Form 3160-5  
(June 2015)UNITED STATES  
DEPARTMENT OF THE INTERIOR  
BUREAU OF LAND MANAGEMENTFORM APPROVED  
OMB NO. 1004-0137  
Expires: January 31, 2018**SUNDRY NOTICES AND REPORTS ON WELLS**  
**Do not use this form for proposals to drill or to re-enter an abandoned well. Use form 3160-3 (APD) for such proposals.****SUBMIT IN TRIPLICATE - Other instructions on page 2**

DJR Operating, LLC requests permission to Plug & Abandon the subject well per the attached Procedure, Current & Proposed Wellbore Diagram, and Reclamation Plan.

**Jicarilla Apache B 9E**

# BLM FLUID MINERALS Geologic Report

## Proposed P&amp;A Wellbore Diagram

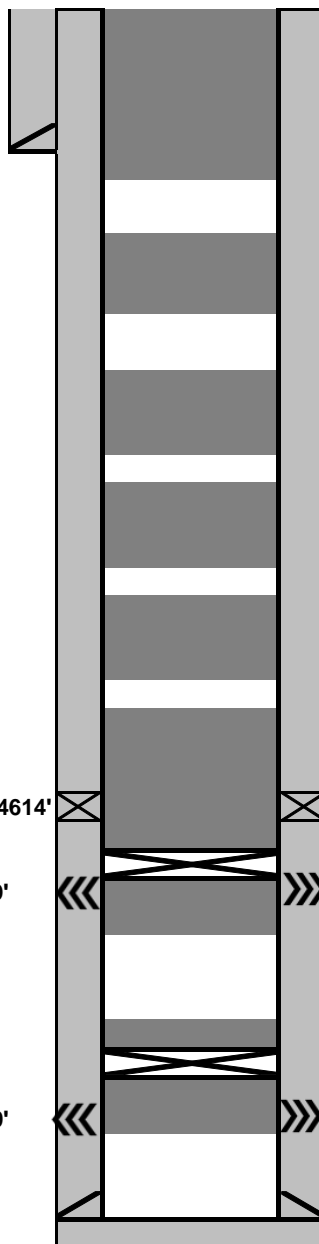
- Plug #6 (Chacra) in the proposed P&A plan should be set from 2670'-2570'.

Plug 6: Chacra: Spot 100' balanced plug of Class G cement from 2672-2722'.

| kpickford                                     | Extend Gallup/Mancos plug, 5380'-4456'. OCD and BLM Mancos pick @ 4506'. |  |        |                |              |
| kpickford                                     | Add a plug 1880'-1780' OCD and BLM Kirtland pick @ 1830'.                |  |        |                |              |
| kpickford                                     | Add a plug 1667'-1567'. OCD and BLM Ojo Alamo pick @ 1617'.              |  |        |                |              |

1. Plugging operations authorized are subject to the attached "General Requirements for Permanent Abandonment of Wells on Federal and Indian Lease."
2. Farmington Office is to be notified at least 24 hours before the plugging operations commence (505) 564-7750.
3. Plug #6 (Chacra) in the proposed P&A plan should be set from 2670'-2570'.
